Technical BULLETIN

RECALL

CERTAIN 2015, 2016, and 2017 SR400 MODELS

FACTORY MODIFICATION CAMPAIGN – Vehicle Emissions Control Information Label

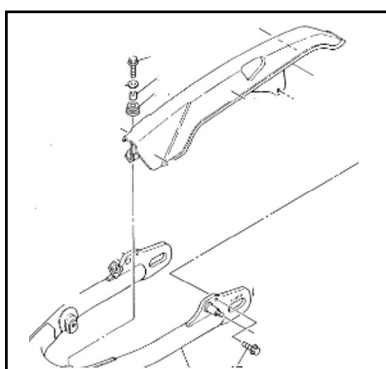
1. Confirm that the unit is within the affected range and it has not been modified by checking Unit Status on YDS (*Service> Warranty Claims / Authorization> Unit Status*).
2. Locate the VECI label on the Chain Case on the left side of the motorcycle. Clean the area of any grease, chain lube, or road grime.

3. Peel off the incorrect VECI label. Clean the surface of any remaining adhesive using Yamalube Brake and Contact Cleaner (p/n ACC-BRKCT-12-00) or a commercial label glue removal product. For tips on label removal, see Technical Bulletin M2017-004R.

- **Brake and Contact Cleaner may instantly damage paint and some plastics. Protect area around label and spray carefully if using.**
 - **Be careful not to remove or damage the Tire Information label next to the VECI label.**
4. Clean and dry the surface thoroughly using soap and water or isopropyl alcohol. Affix the corrected VECI label.

- **The surface must be completely clean and dry before affixing the new label.**
- **Be careful not to cover any part of the Tire Information label.**

TIP: Use the mold line on the chain guard as a guideline for lower edge of the new label's position.
